NOTICE TO PROPOSERS:

This Addendum consists of: (22) 8-1/2" x 11" pages and (7) Re-issued 24" x 36" full sized sheets.

PROJECT NUMBER: 2408_PN DATE/TIME OF PRE-BID MEETING: June 24, 2025 at 1:00 PM LOCATION OF PRE-BID MEETING: 2509 TX-105, Brenham, TX 77833

MECHANICAL NEW FLOOR PLAN

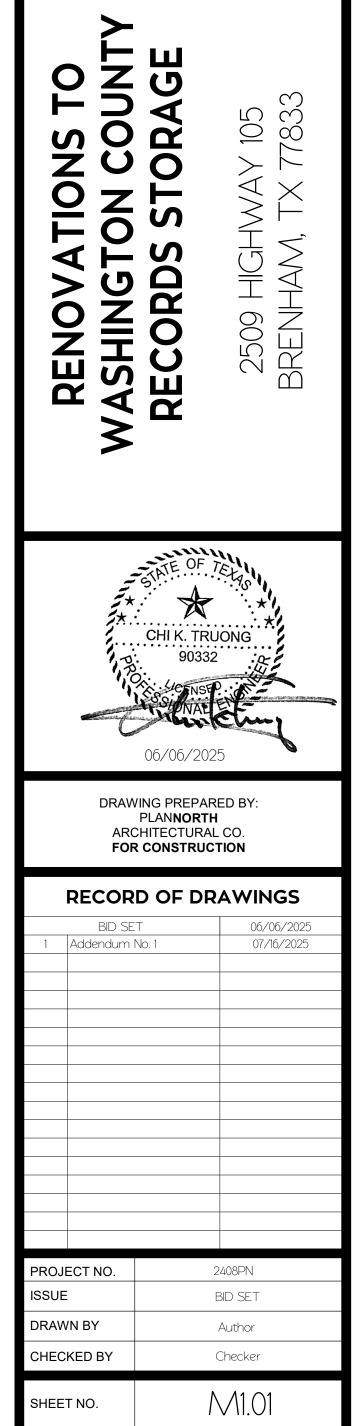
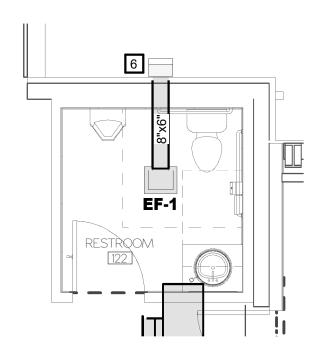
- 01 Added circuit for overhead door and misc. edits to wiring requirements.
- F. Sheet M 1.01 Mechanical New Floor Plan
 - 01 Added notes for exposed ductwork in Room 121.
- G. Sheet M 2.00 Mechanical Schedules
 - 01 Modified notes for ACU & ACCU Schedule.

MECHANICAL SCHEDULES

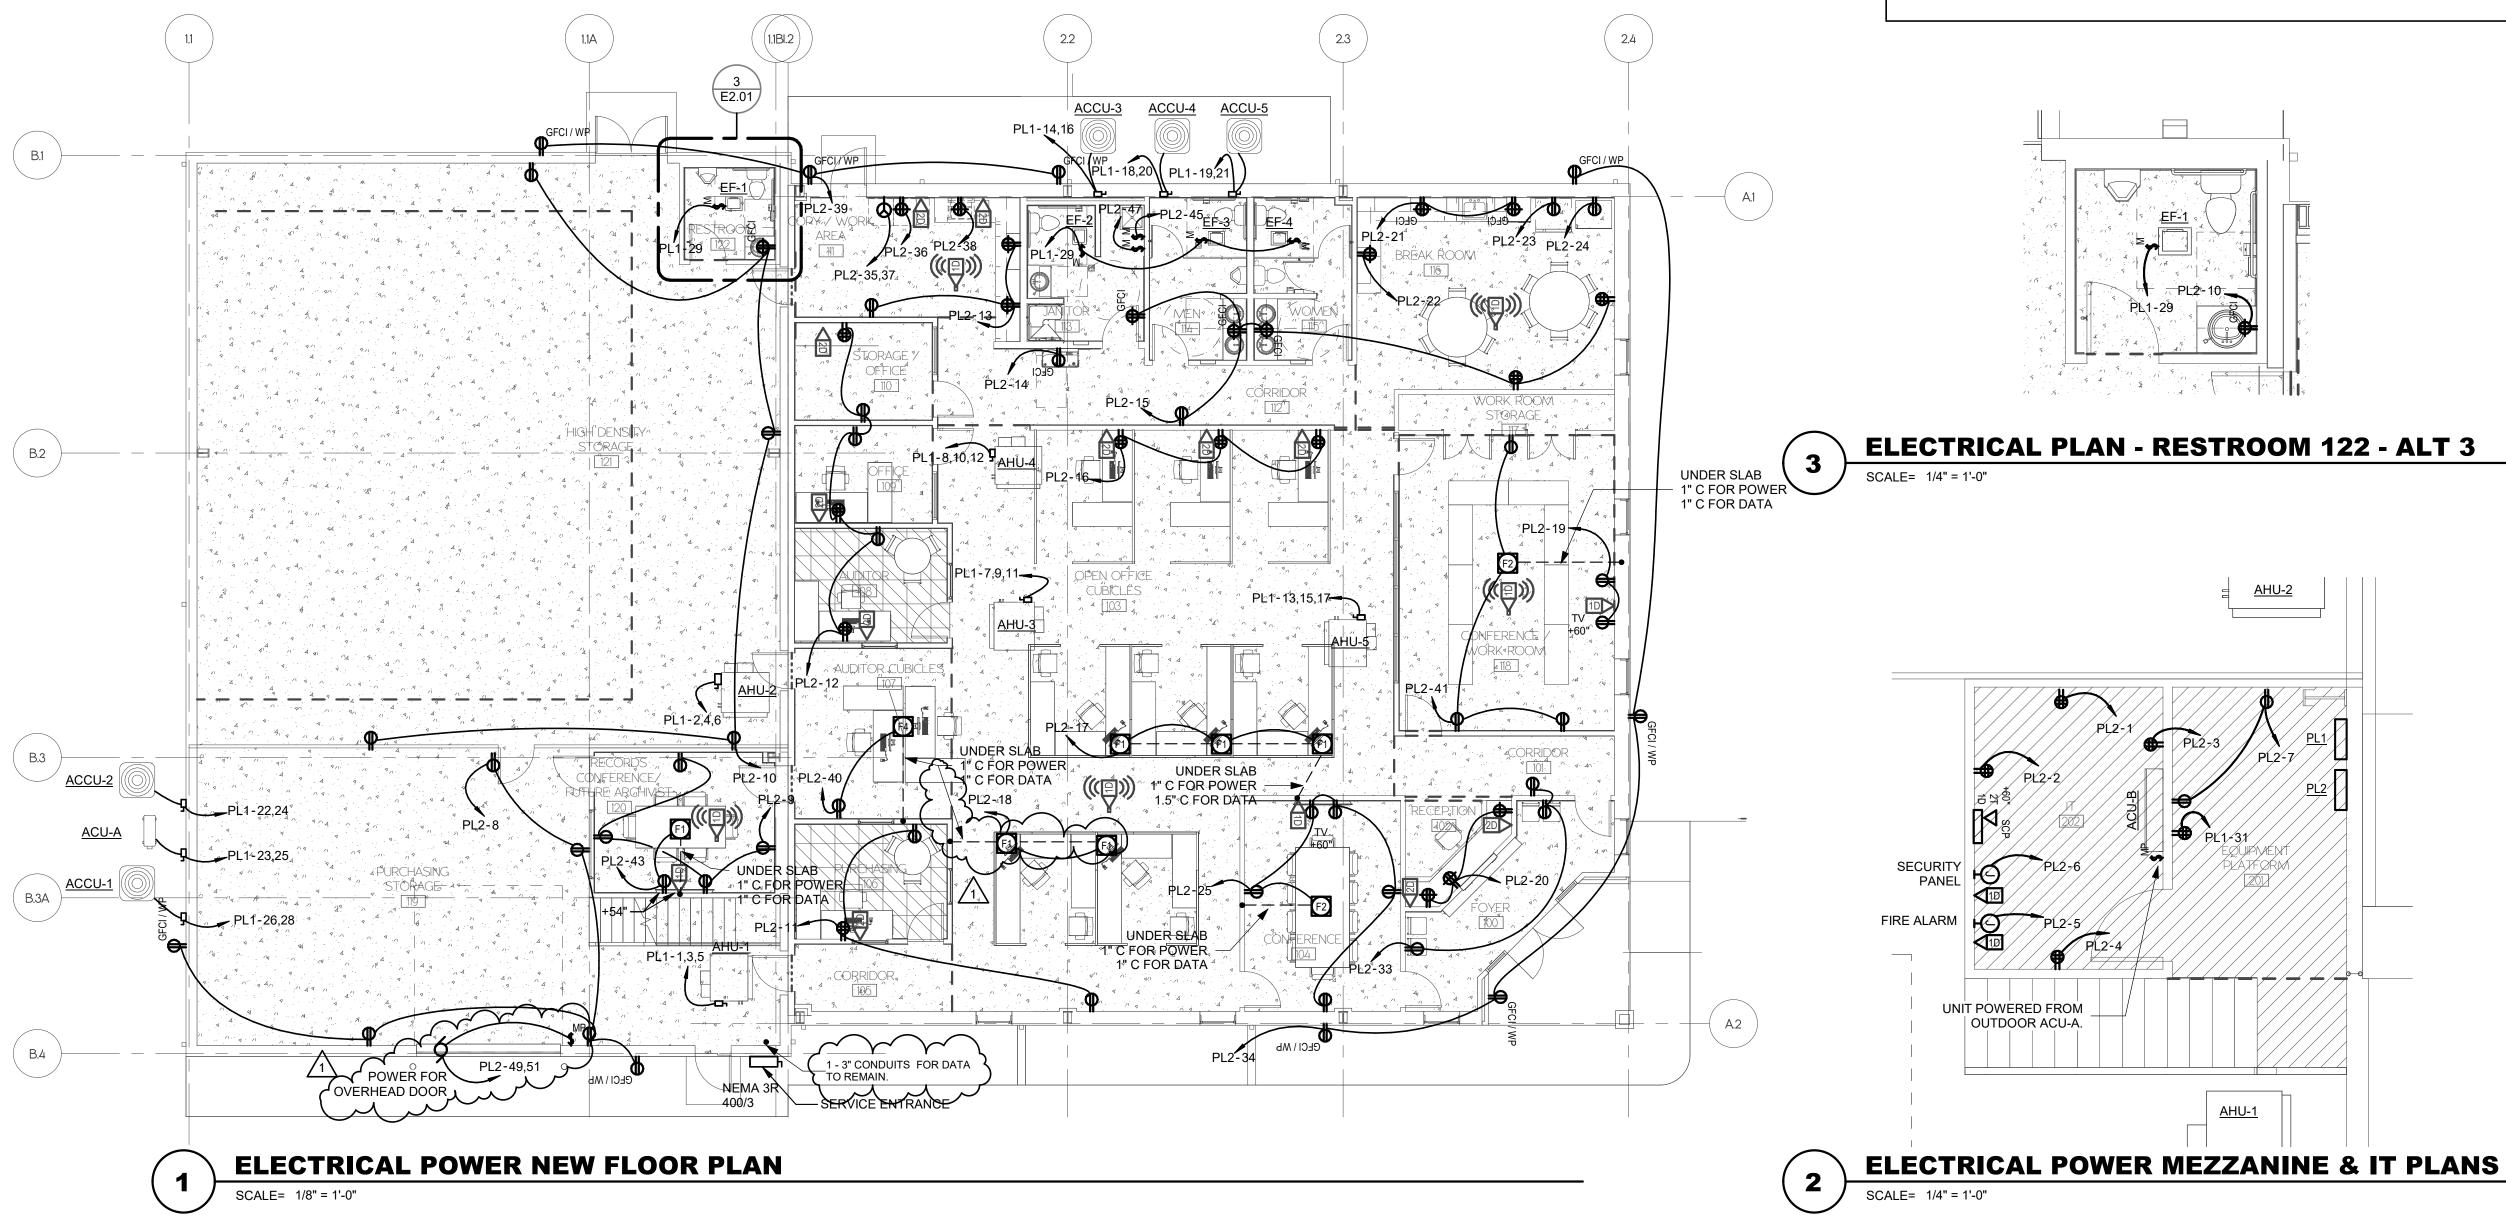
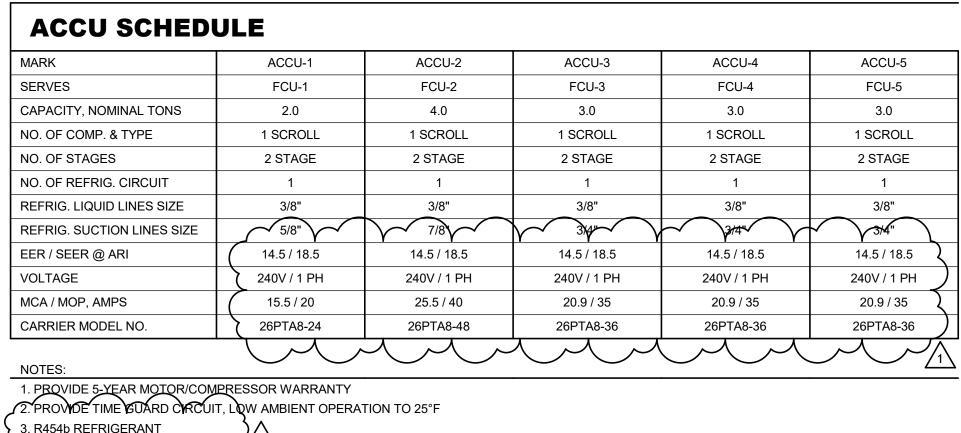
- 16 Question: Scope: HVAC, Sheet: M2.00. Condensing units appear to be specified with a discontinued model utilizing R-410A refrigerant. R454B has replaced this. Please verify the ACCU model required.

- a. Answer: Replacement of discontinued refrigerant is acceptable.
- 17 Question: Scope: HVAC, Sheet: M2.00. The AHU appear to have incorrect unit listed on schedule. Assumption is that a 39L-11PD unit should be listed. Please verify which AHU model is required.

ELECTRICAL POWER NEW FLOOR PLAN

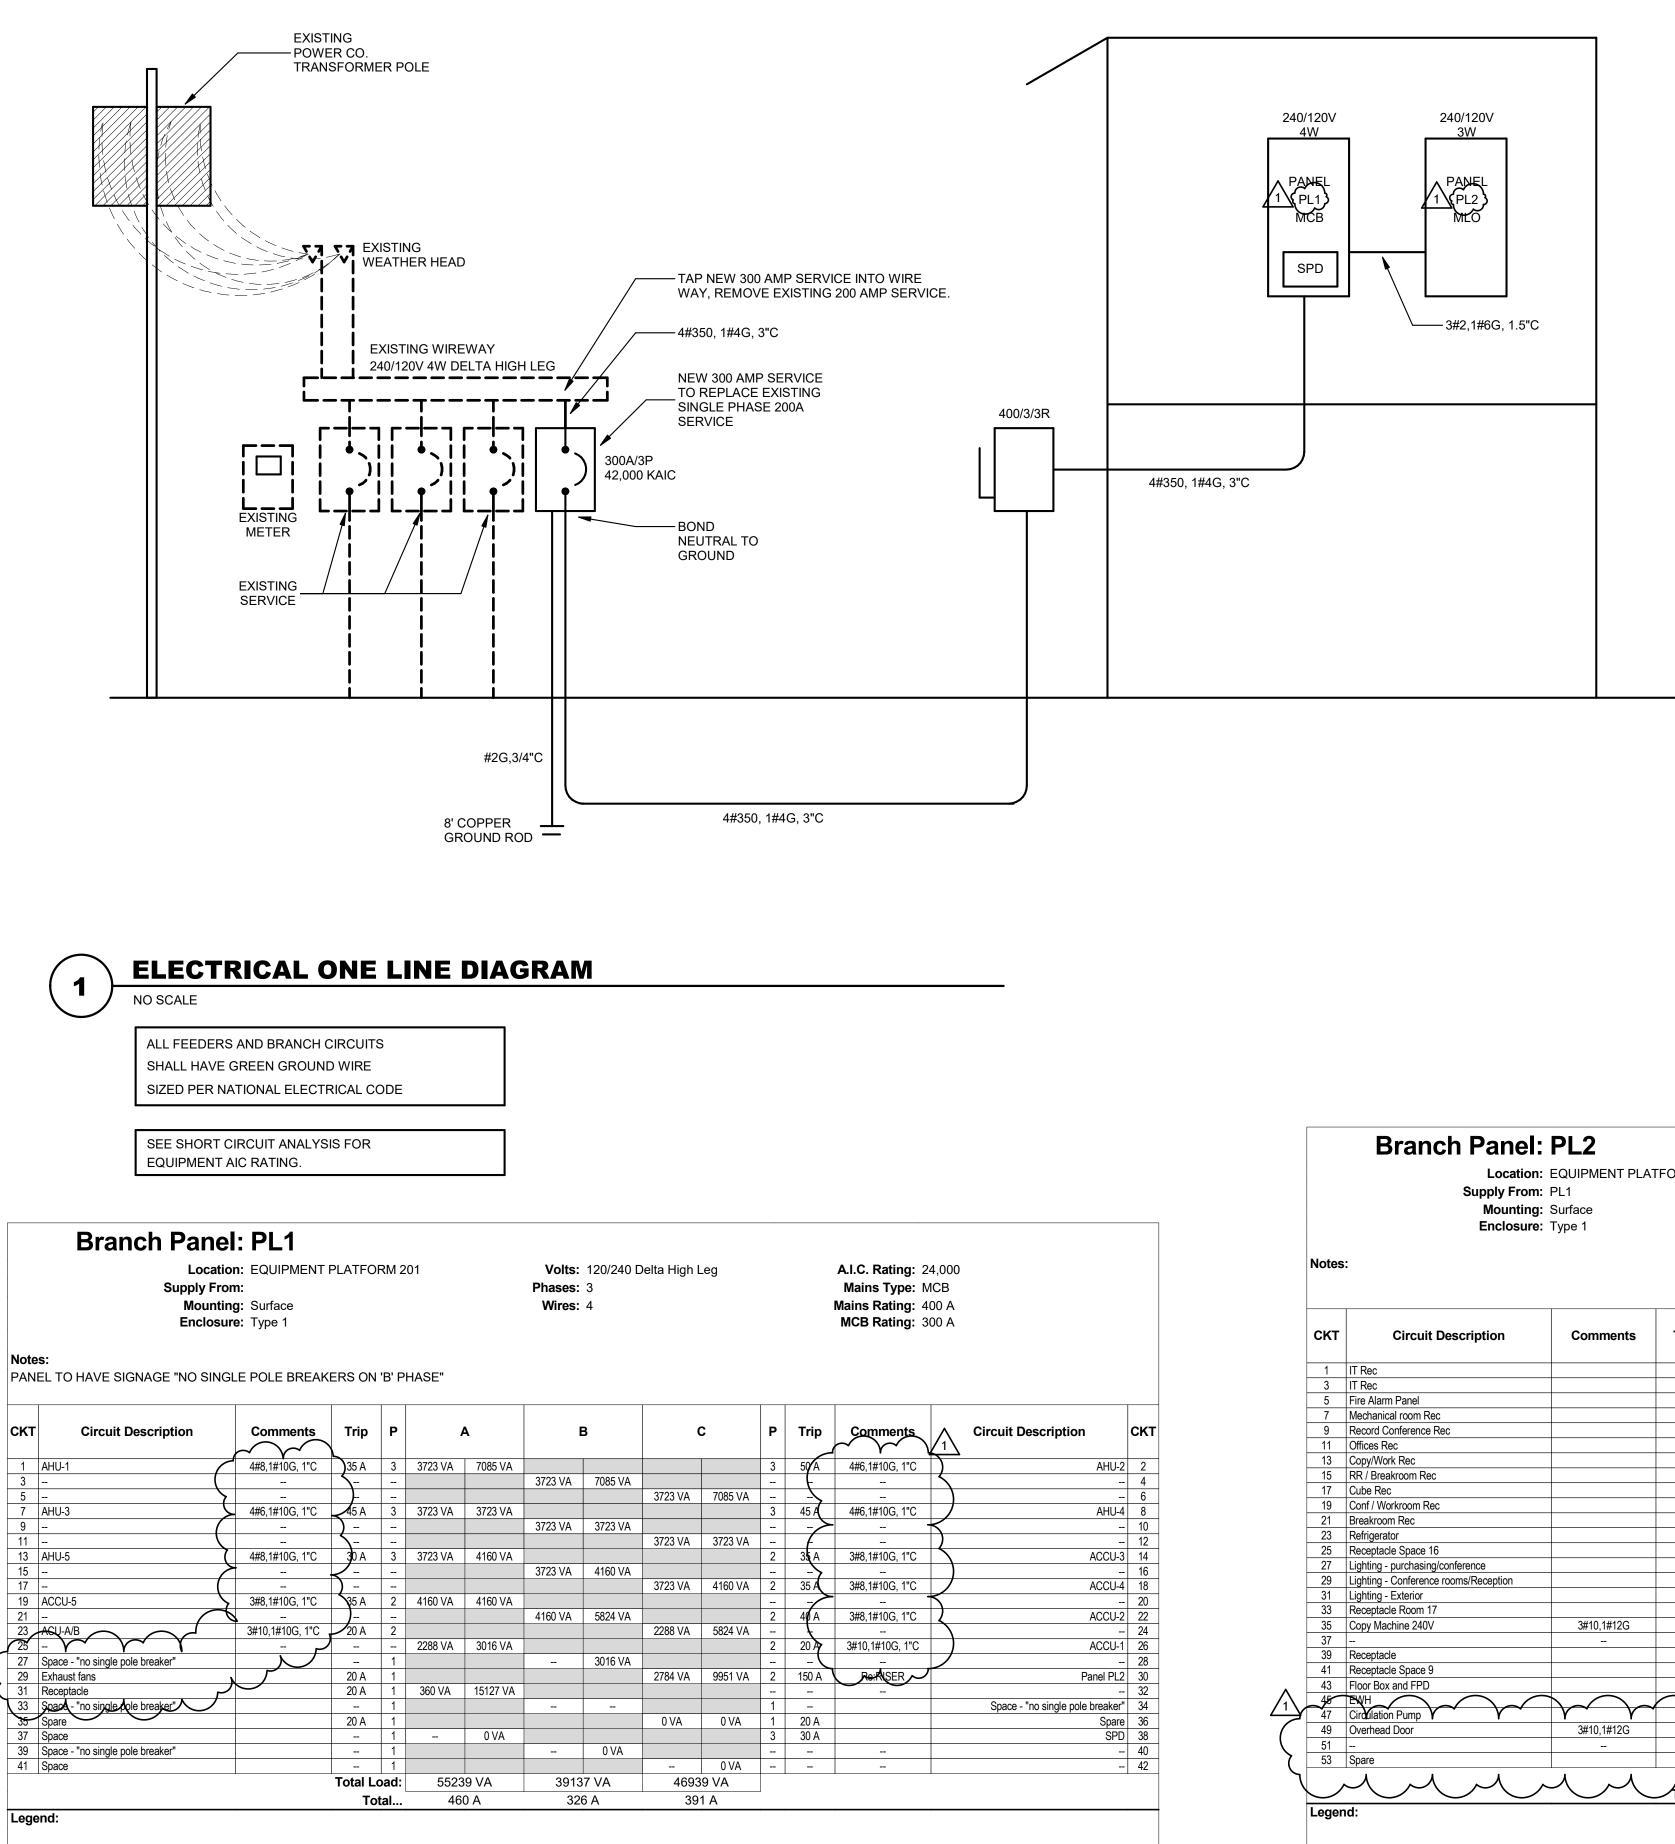
- 01 Question: Drawing sheet ES1.00 currently shows 1-3" underground conduit for the new electrical service. At the pre-bid meeting it was expressed that the existing conduit in place would be used for the new elect service. The existing conduit is currently a 2" line. Can you please confirm if a new 3" underground conduit is to be installed which will require saw cutting the existing sidewalk, driveway & parking area?

- a. Answer: Contractor is required to upsize the conduit to 3" to accommodate the larger electrical service for the building. The existing 2" must be replaced with the 3" per the Plan.

D. Sheet E 2.01 Electrical Power New Floor Plan

01 Added circuitry for overhead door and added clarification for service entry conduits.
